# UNITED STATES PATENT AND TRADEMARK OFFICE

APPLICATION NO.	FILING DATE	FIRST NAMED INVENTOR	ATTORNEY DOCKET NO.	CONFIRMATION NO.
09/898,958	07/03/2001	Jack V. Smith	1414.47	9735
21901	7590	06/09/2009	EXAMINER	
SMITH HOPEN, PA			PAGAN, JENINE MARIE	
180 PINE AVENUE NORTH			ART UNIT	PAPER NUMBER
OLDSMAR, FL 34677			3728	
			MAIL DATE	DELIVERY MODE
			06/09/2009	PAPER

<b>Office Action Summary</b>	<b>Application No.</b>	<b>Applicant(s)</b>	
	09/898,958	SMITH, JACK V.	
	<b>Examiner</b>	<b>Art Unit</b>	
	JENINE M. PAGAN	3728

## **DETAILED ACTION**

***FIG. - 1***

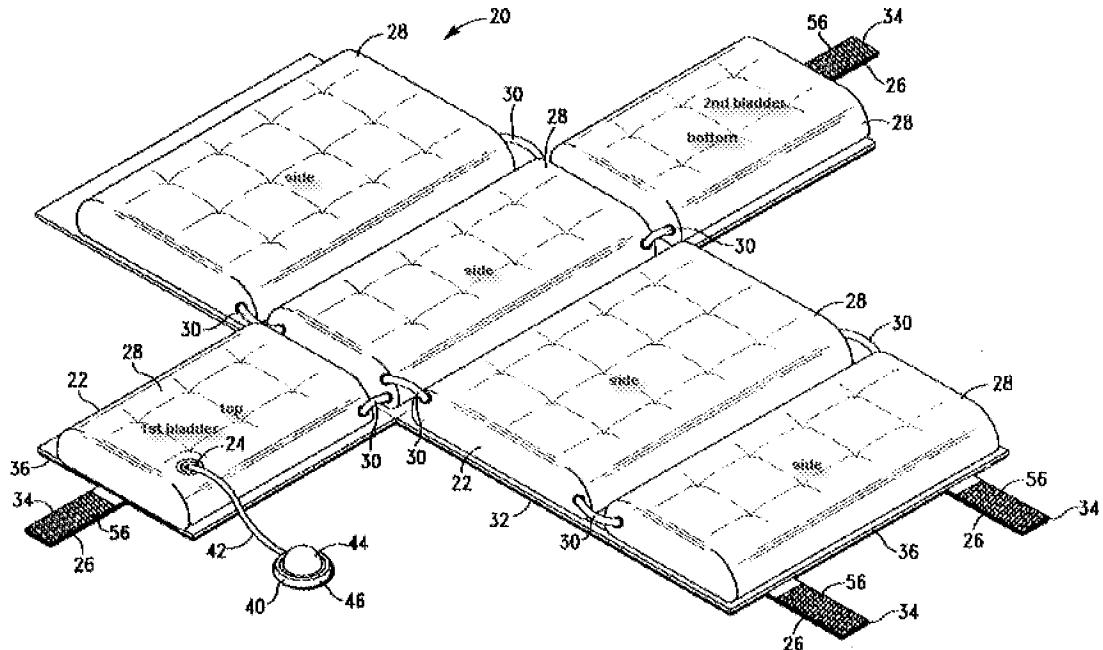
**5. Claims 6-7 and 12-18 are rejected under 35 U.S.C. 103(a) as being unpatentable over Kim (US 5,624,035) in view of Slepian (US 6,182,826 B1).**

**Claim 6:** Kim discloses an inflatable box (Col 3:29-46, Fig. 1 and 3):

- a box 20 having a hollow interior defined by a top wall, a bottom wall, and sidewalls interconnecting said top and bottom walls;
- a first inflatable bladder 28 disposed within said hollow interior of said box 20, wherein said first inflatable bladder is connected to each said sidewall and wherein said first inflatable bladder is disposed in protecting relation to said bottom wall of said box 20;

- an opening formed in said box (Fig 2);
- said inlet port adapted to be connected to a source of gaseous fluid under pressure;
- said outlet port 30 being in fluid communication with said first inflatable bladder so that said first inflatable bladder is inflated when said source of gaseous fluid under pressure is connected to said inlet port (Col 3:40-46);
- whereby said first inflatable bladder 28 when inflated serves as a cushioning means for said item during shipping (Col 4:38-42 and Fig. 3)

- a second inflatable bladder 28 disposed in said hollow interior of said box in cooperative relation to said first inflatable bladder 28 to provide an enhanced cushioning means
- wherein the box 20 has four side walls (see figure above) and closable flaps 34 on the top horizontal and bottom horizontal sections

- first inflatable bladder 28 being disposed in protecting relation to said sidewalls (see figure above) of said box 20

- first inflatable bladder 28 further comprises a bottom inflatable lumen shaped to cover said bottom wall (see figure above) of said box 20
